TECHNICAL BULLETIN
ETI FIRE SYSTEM
LOP DETECTION BYPASS

FIG -1

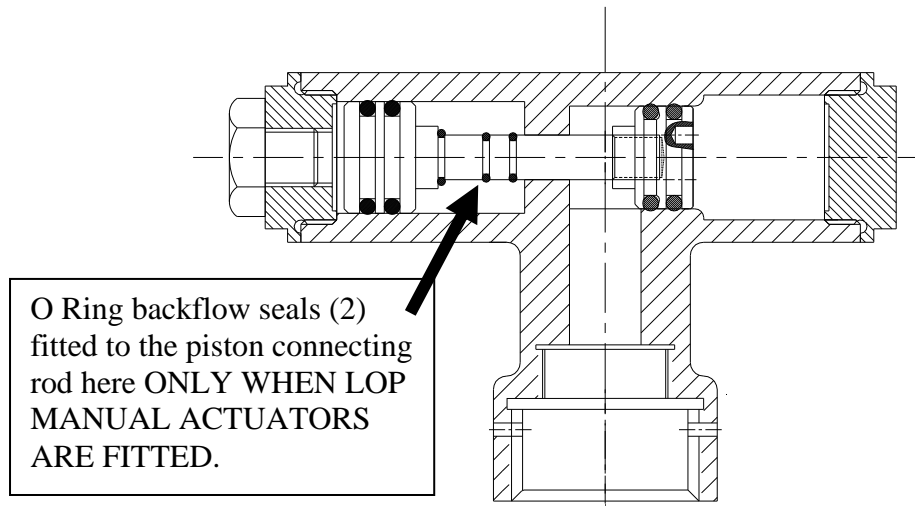
If however, an all LOP system is built, using LOP manual actuators, it will be undesirable to have foam bypass to the manual actuator during discharge. For this reason, backflow seals are to be fitted **ONLY** when LOP manual actuators are fitted. See fig 1 and technical manual for correct part numbers. During discharge, these seals seal off the gland to the actuation chamber, and prevent foam bypass to the manual actuator. These seals however will not prevent normal by pass if a leak occurs as described above.

WARNING O ring backflow seals are not to be fitted when any ROP devices are connected. This is because the seals can cause a pressure lock in the actuator chamber and prevent the valve from effectively opening, resulting in slowed discharge.
